Construction Change Directive

PROJECT: *(name and address)*
Highland Township Fire Station 2
PIA #18-122B

CCD INFORMATION:
Directive Number: 001
Date: July 13, 2021

“EXHIBIT A” – CCD NO. 1

C-1 SITE PAVING & GRADING PLAN

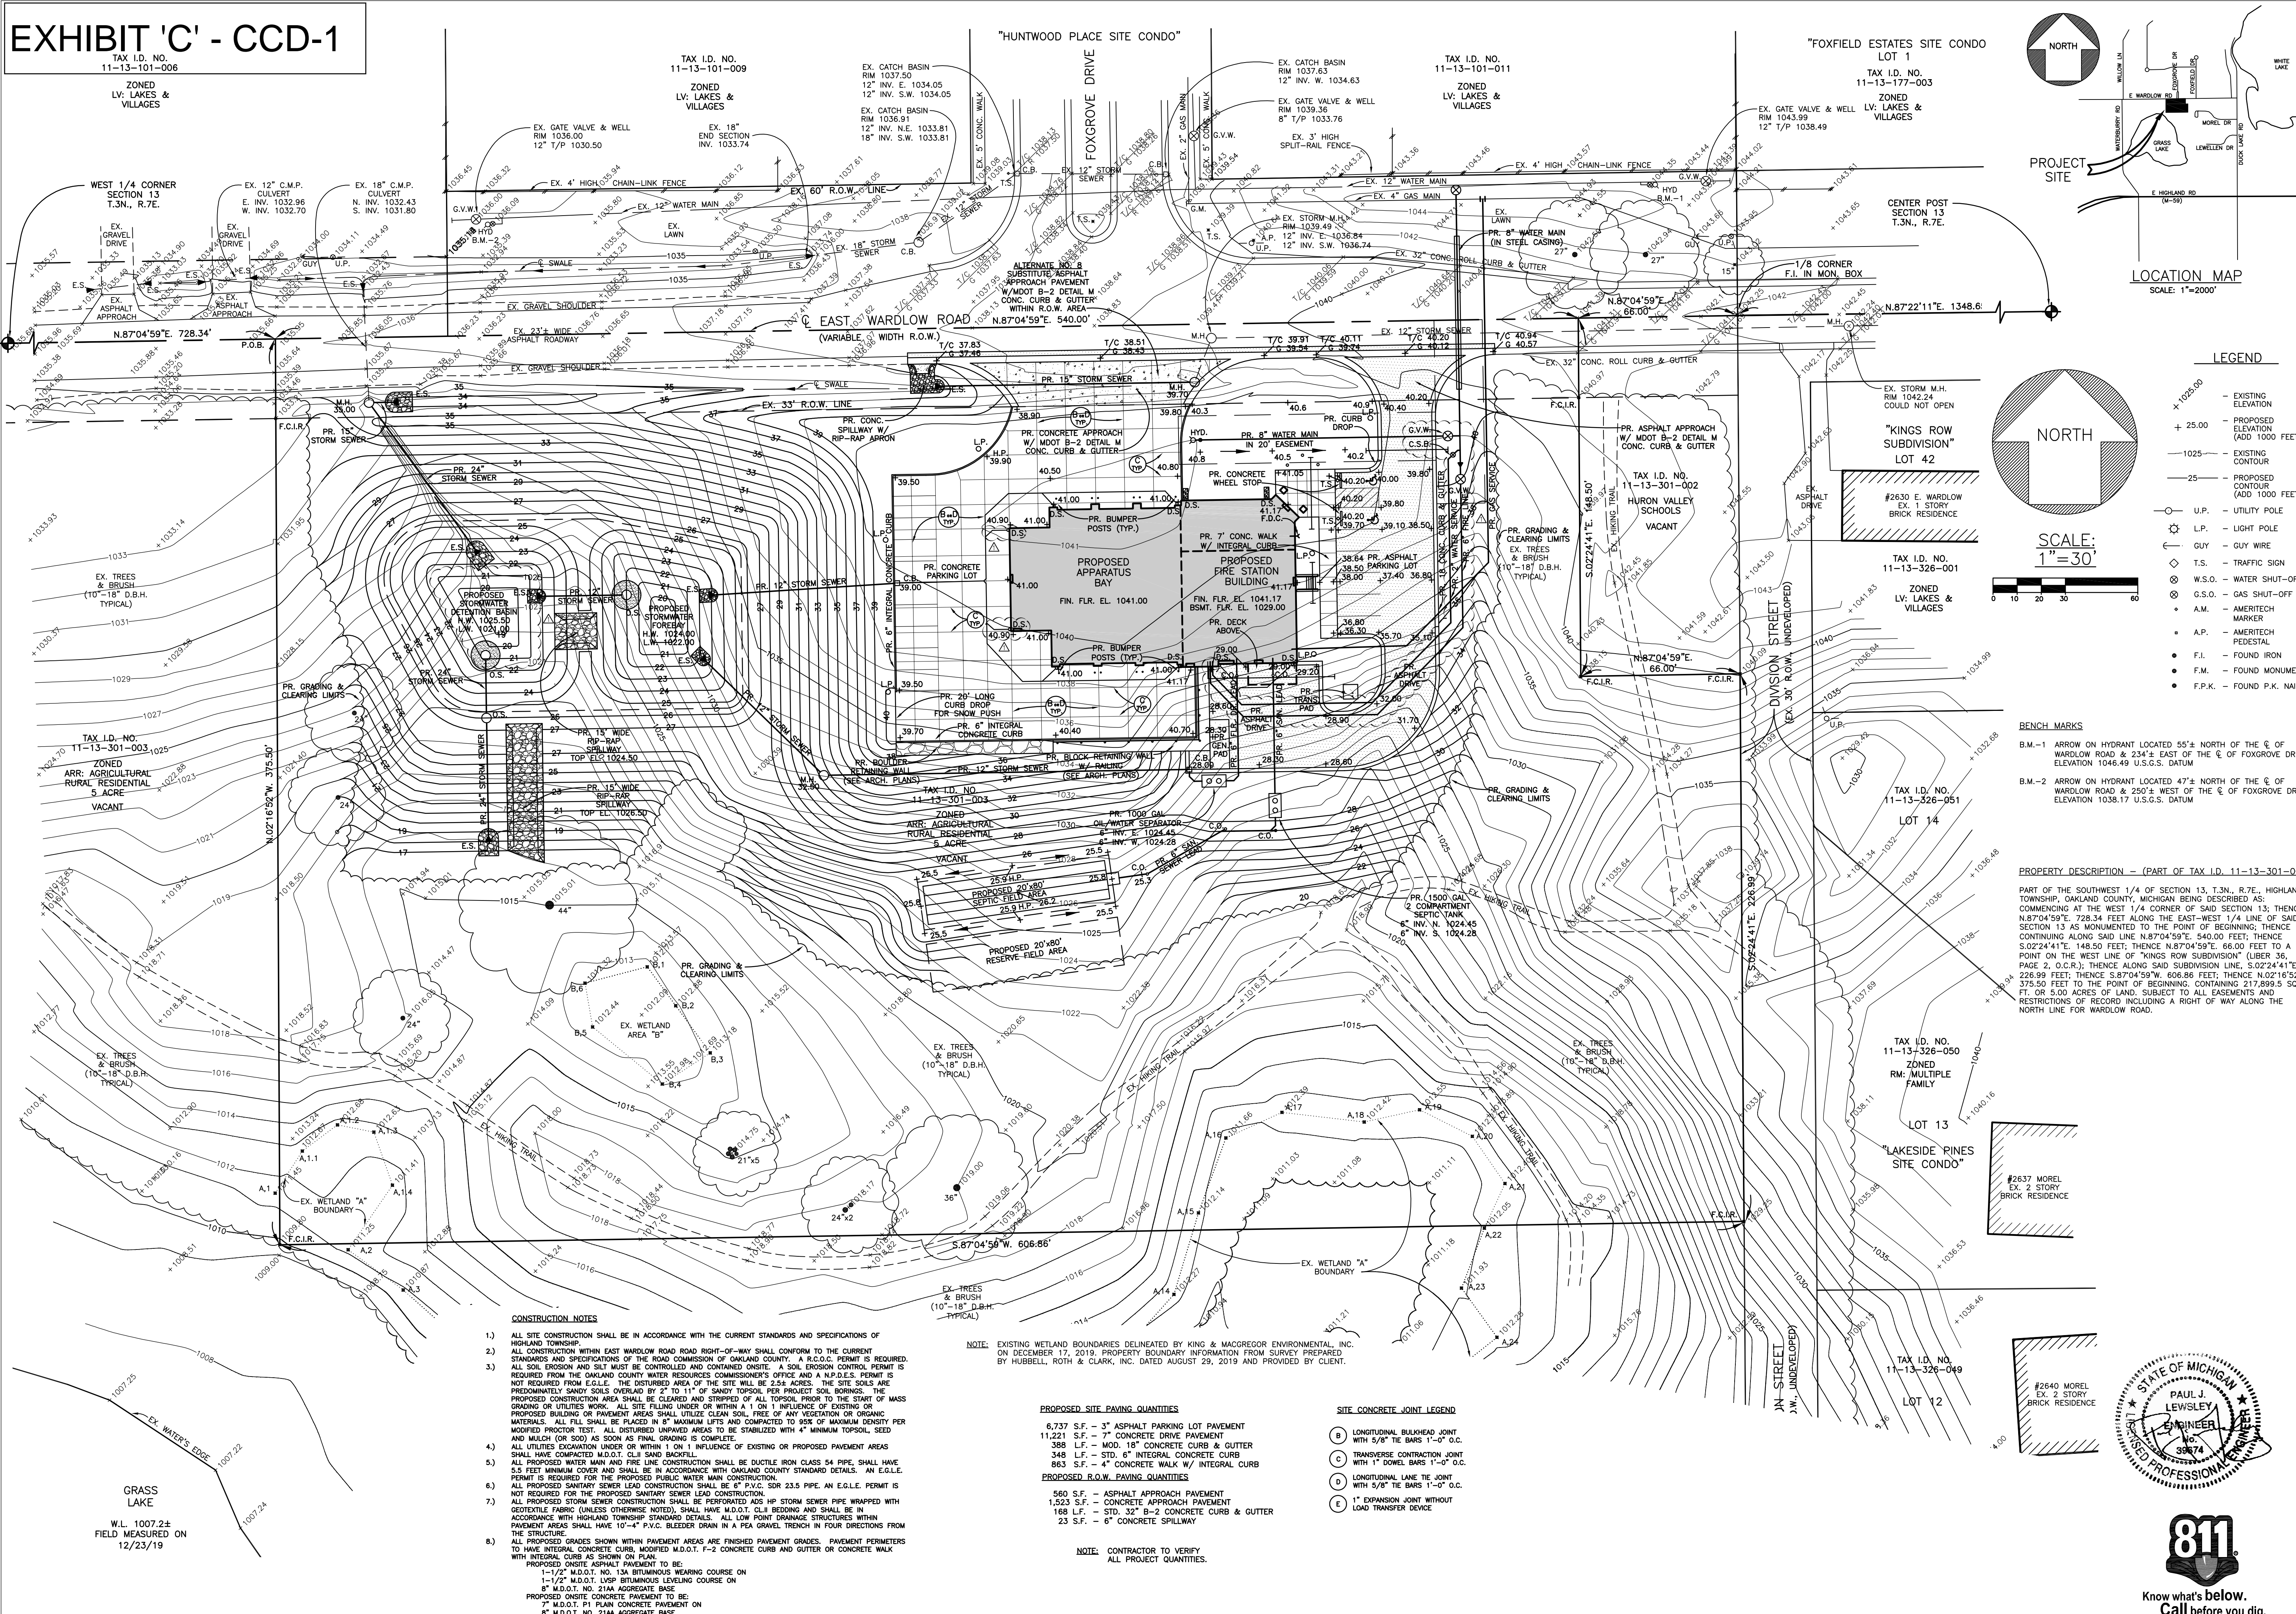
- A. Added 2' deep sediment sump in Stormwater Detention Basin.
- B. Replaced single center downspout pipe on building west end with ones at northwest & southwest building corners.
- C. Replaced single 8" water lead south of hydrant lead tee with separate 2" water service and 6" fire line.

C-3 SITE UTILITIES PLAN

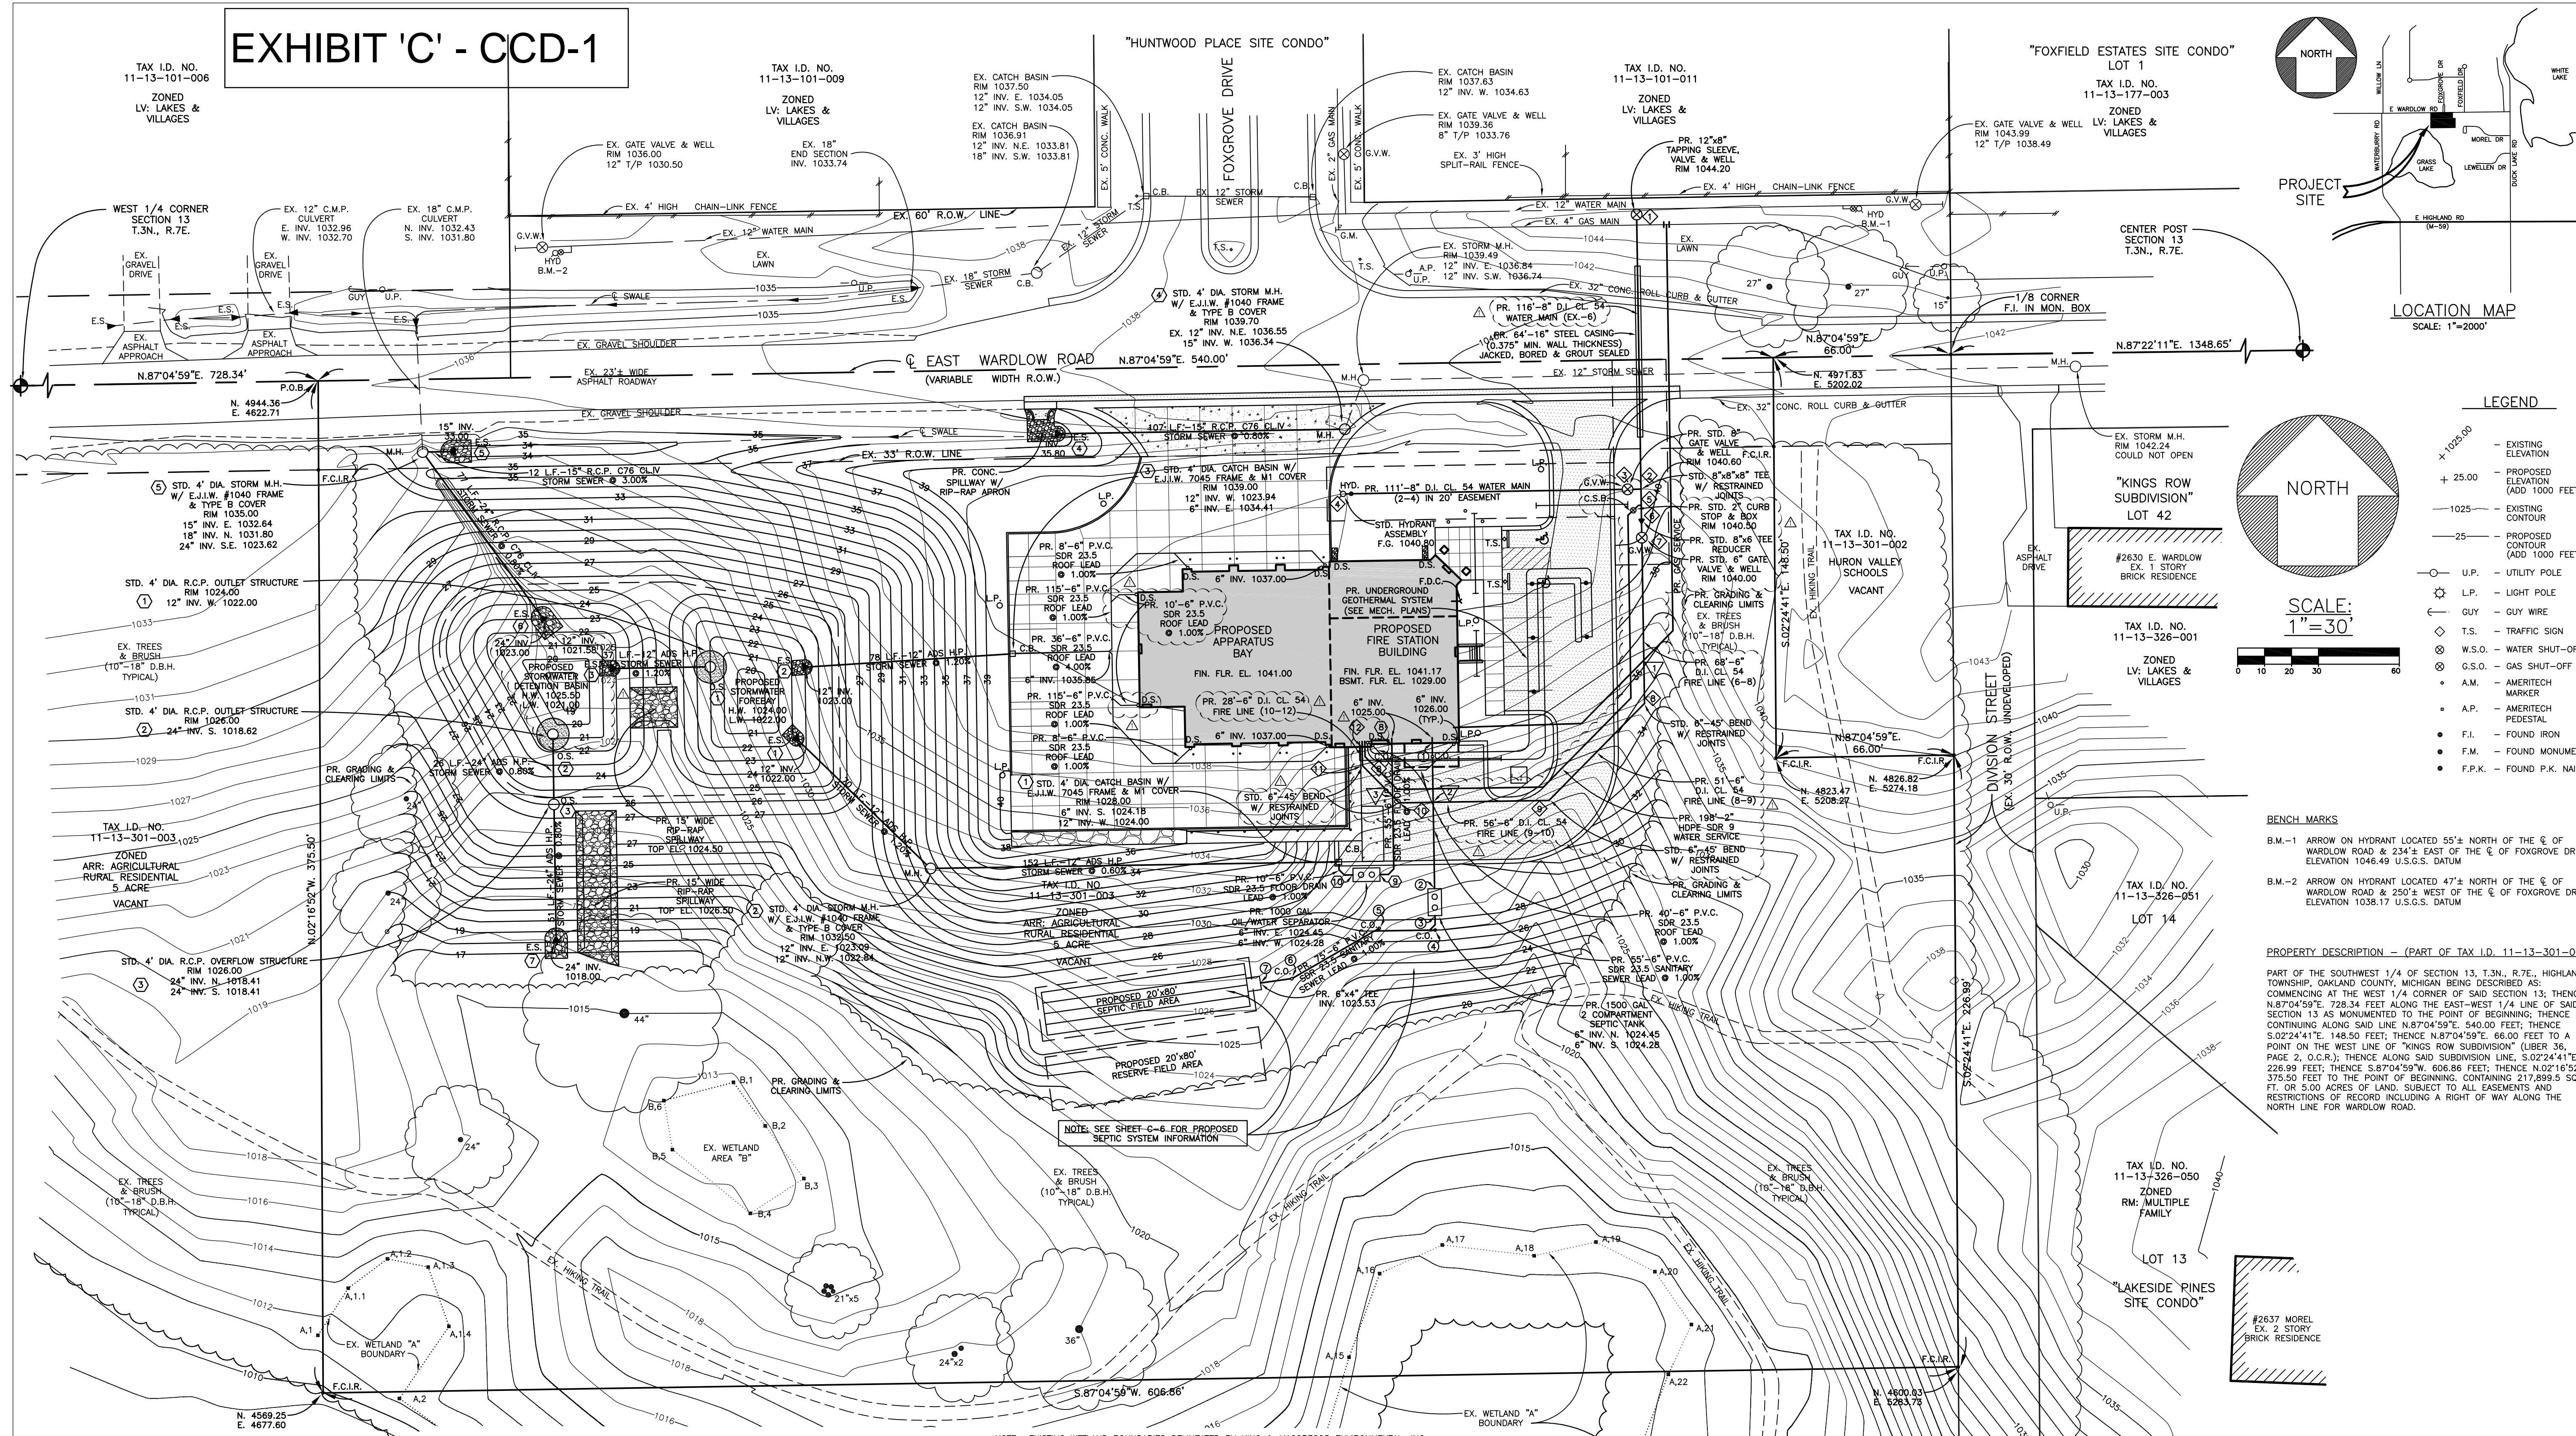
- A. Added 2' deep sediment sump in Stormwater Detention Basin.
- B. Replaced single center downspout pipe on building west end with ones at northwest & southwest building corners.
- C. Replaced single 8" water lead south of hydrant lead tee with separate 2" water service and 6" fire line.
